Wollongong Local Planning Panel Assessment Report | 12 December 2023

WLPP No.	Item No. 1
DA No.	DA-2023/402
Proposal	Fit-out of North Wollongong Surf Club for restaurant
Property	North Wollongong Surf Club, Stuart Park, George Hanley Drive, NORTH WOLLONGONG
Applicant	Mr Terry Wetherall
Responsible Team	Development Assessment and Certification - City Centre Major Development Team (RW)
Prior WLPP meeting	N/A for this proposal however DA-2021/300 for the use of the first floor as a restaurant was considered by the Panel on 3 August 2021

ASSESSMENT REPORT AND RECOMMENDATION

PLAN NO. 04 **REVISION:** C

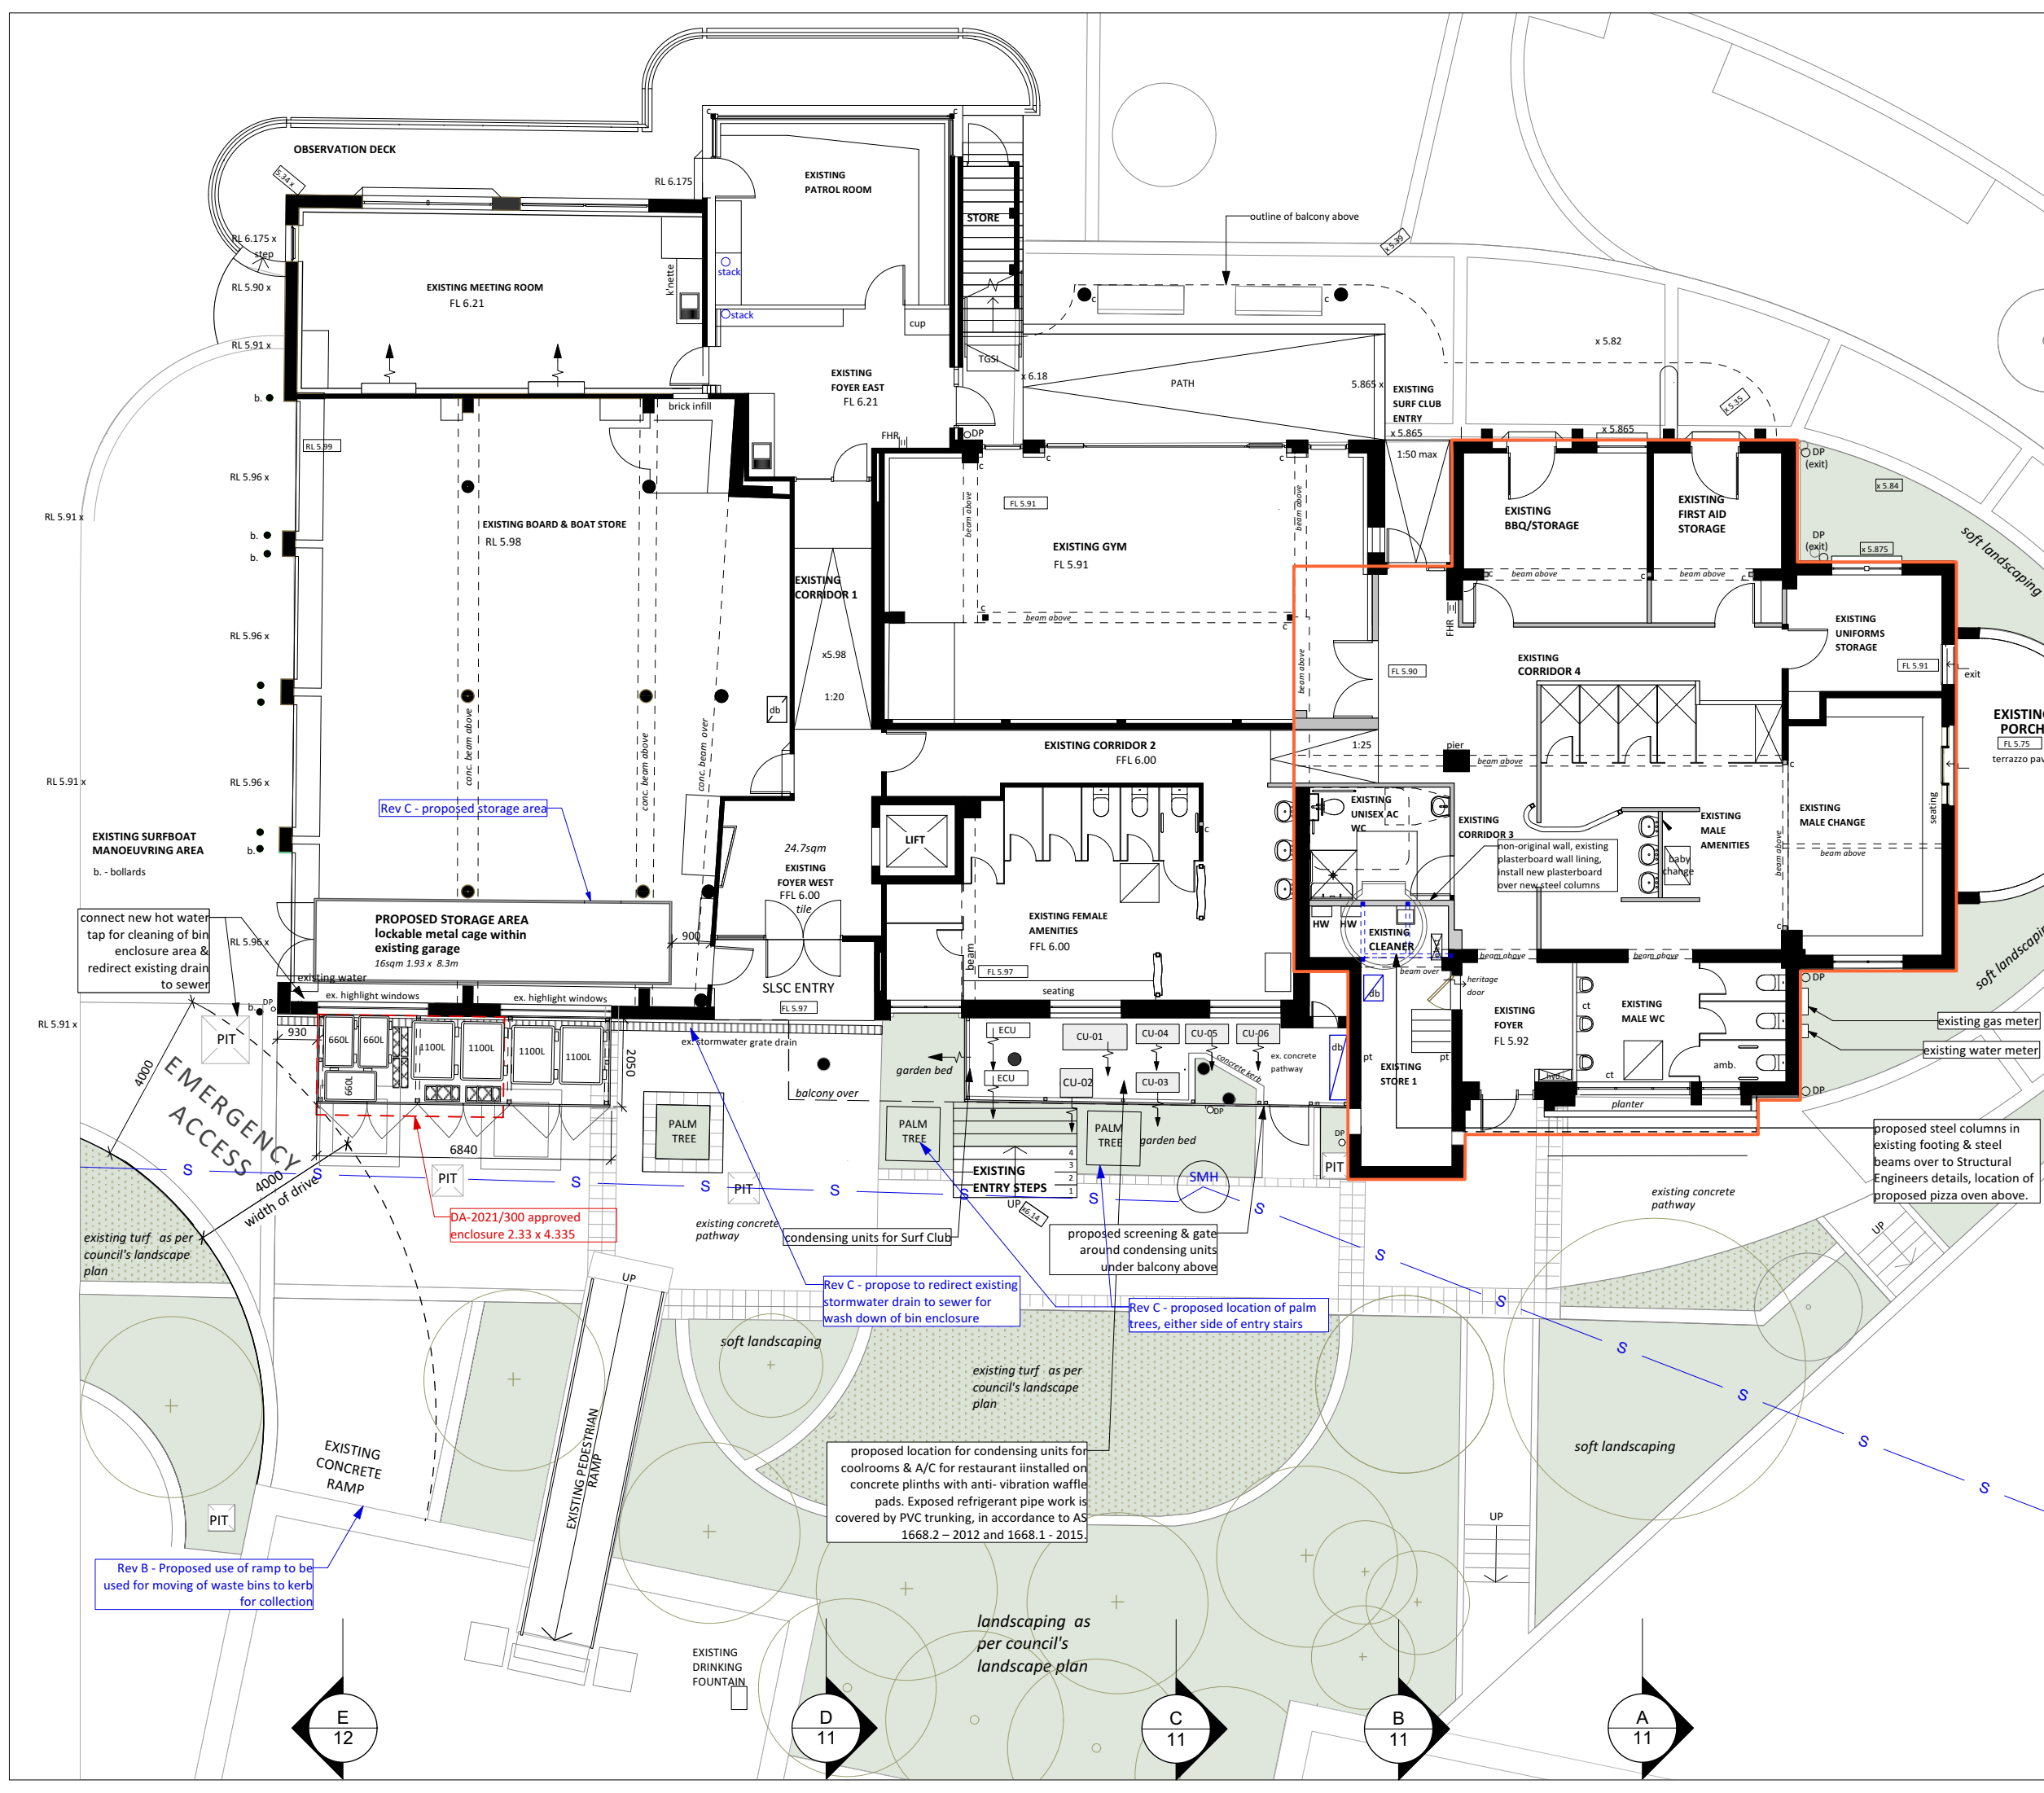
Approval is sought for keg room in the north-western corner of the ground floor surf club boat and board storage area. The keg room is identified as "proposed storage area" on the ground floor plan (Dwg 04-C). It consists of a lockable metal cage with an area of 16m². The kegs would need to be moved to the first floor for refrigeration in the coolroom/s. The applicant has advised that full kegs (in the coolroom) at any one time would be around 20, and empty kegs would be around 10. Frequency of pick up and delivery would be weekly.

Given the generous floorplate of the restaurant, there is opportunity to provide storage elsewhere on the first floor to accommodate the empty kegs and kegs waiting to be refrigerated, rather than occupying ground floor surf club storage space for this purpose. This will ensure ongoing and future surf club operations are not compromised by the restaurant use. The submission does not demonstrate the storage capabilities of the "storage area" or if any racking stacking is possible. Notwithstanding the keg storage on the ground floor is not supported, the need for the size indicated has not been demonstrated in the material provided.

The proposed Keg Room located on the ground floor of the Surf Life Saving Club Building (identified as "Proposed Storage Area" on Dwg 04-C) is not approved by this consent. This proposed change to the building must be deleted from the Construction Certificate Plans and alternate arrangements made to store this equipment within the existing approved restaurant footprint.

Figure 9: Proposed signage

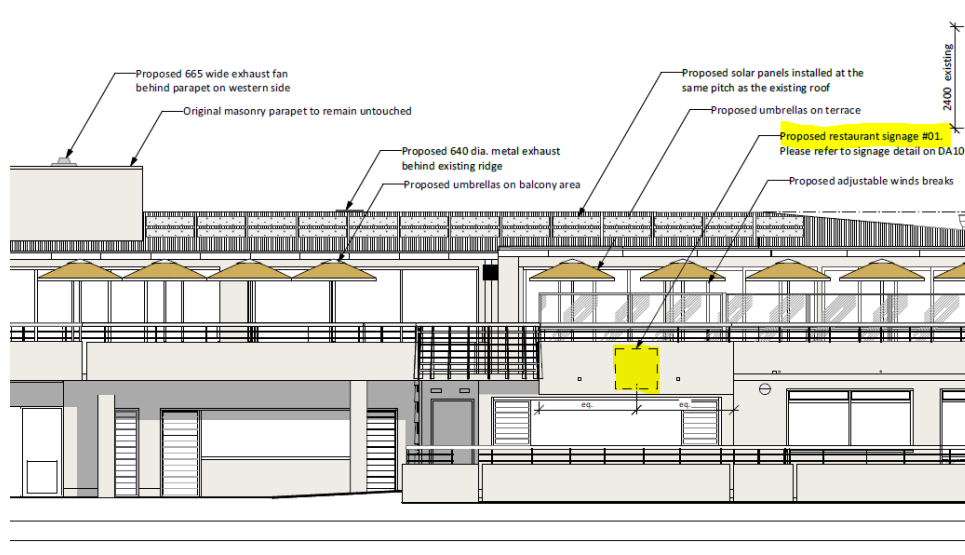
Comment – the location of the proposed business identification signage is sought to be changed under the current application. The details, design and materials of the sign have been assessed and are supported.

The current proposal seeks to relocate this signage and add another sign on the eastern elevation of the building. Both signs have the wording 'The Boat house' and are 1m x 0.95m with LED backlit lettering and their proposed locations shown below:

Figure 10: Proposed waste enclosure (enlarged from that approved under DA-2021/300).

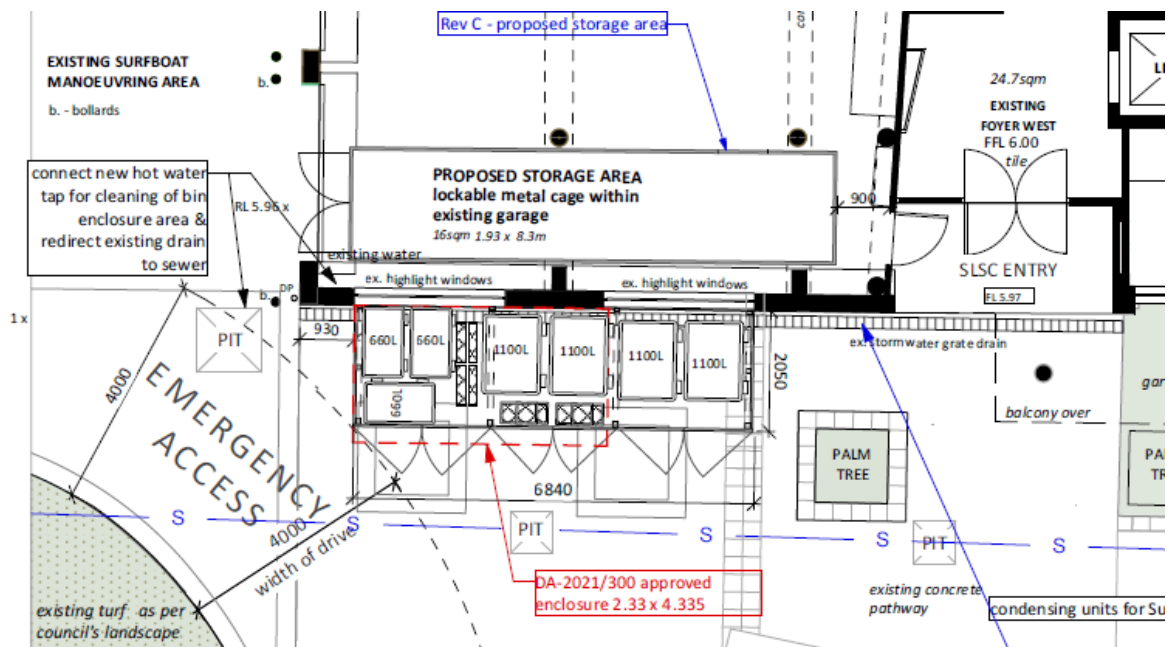
Comment – the waste enclosure is proposed to be increased in size as part of the current application. Further conditions regarding waste management are recommended to be imposed on this consent to ensure waste is dealt with effectively for the restaurant.

Council's Landscape Officer reviewed the application and raised concerns regarding a conflict between the proposed waste enclosure and recently planted palm trees. Concerns were also raised regarding the impact of the enlarged waste enclosure on access for emergency and beach vehicles to the northern part of the surf club. Manoeuvrability of vehicles around the surf club building has been resolved by the submission of revised plans. Conditions of consent are recommended to require the developer to consult with Council to relocate the palm trees to a suitable alternate location in the vicinity of the surf club building.

Based on the expected waste generation, approval is sought for the enlargement of the external waste storage area to 14sqm, as shown below:
